# PRODUCT UPDATE MEMO

## SEMICONDUCTORS

### Change to Country of Origin

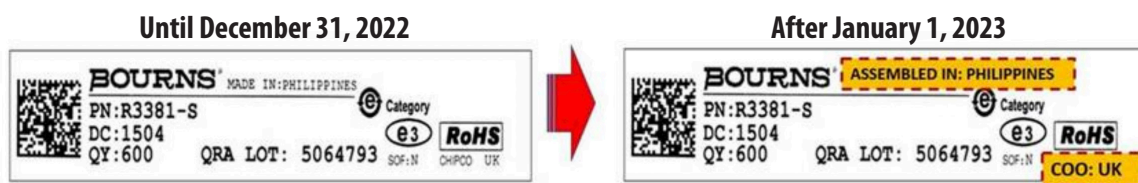
Below please find an example of how the label will change to clearly show country of origin as “COO \_\_\_\_\_” and place of final assembly as “Assembled in \_\_\_\_\_.”
